Access Compliance Report

Public Rights-of-Way

(Curb Ramps)

Intersection ID: 18759	Main Street: QUIET_BAY_CT	Cross Street: ROCK_ISLAND_RD	Location: E
ADA ID: 5E8530D9E1C4	Ramp Type: PerpDiag	Initial Pass/Fail: Fail	Overall Compliance: No
		Severity Score: 50

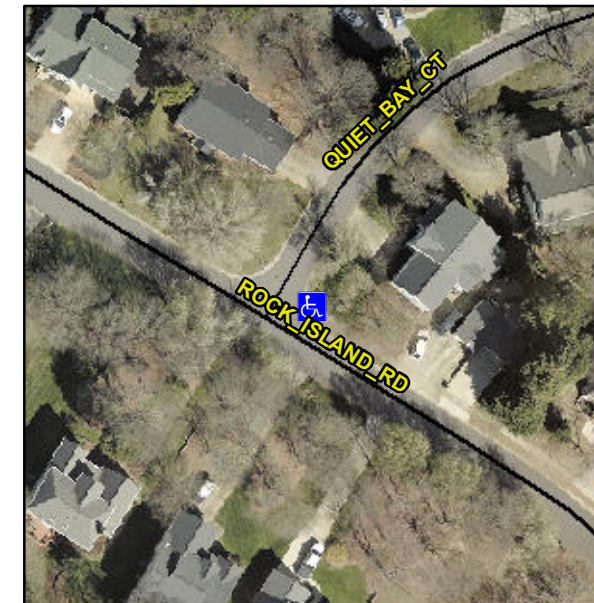
Not Found, R304.2.2, R304.5.3

Compliance	Description	Data	Compliance	Description	Data
N/A	Ramp Length (in)	92.0	No	Ramp Slope (%)	12.8
Yes	Ramp Width (in)	48.0	No	Ramp XSlope (%)	14.9
N/A	Flare Type LT	N/A	N/A	Flare Type RT	N/A
N/A	Flare Slope LT (%)	N/A	N/A	Flare Slope RT (%)	N/A
N/A	Flare Traversable LT?	N/A	N/A	Flare Traversable RT?	N/A
N/A	Landing Length (in)	N/A	N/A	DWS Provided?	N/A
N/A	Landing Width (in)	N/A	N/A	DWS Contrast?	N/A
N/A	Landing Slope (%)	N/A	N/A	DWS Length (in)	N/A
N/A	Landing X Slope (%)	N/A	N/A	DWS Full Width?	N/A
N/A	Landing Curb? (Y/N)	N/A	N/A	DWS Offset (in)	N/A
N/A	Shared Landing?	N/A			
N/A	Gutter Ponding?	N/A	N/A	Gutter Slope (%)	N/A
N/A	Gutter Lip Ht (in)	N/A	N/A	Gutter X Slope (%)	N/A
N/A	Painted X Walk1?	No	N/A	Painted X Walk2?	No
	X Walk 1 Direction	To NW		X Walk 2 Direction	To SW
N/A	X Walk 1 Width (in)	N/A	N/A	X Walk 2 Width (in)	N/A
	X Walk 1 Slope (%)	2.5		X Walk 2 Slope (%)	7.4
	X Walk 1 X Slope (%)	9.6		X Walk 2 X Slope (%)	9.5

Remove & Replace Curb Ramp With Two New Directional Ramps or Equivalent.
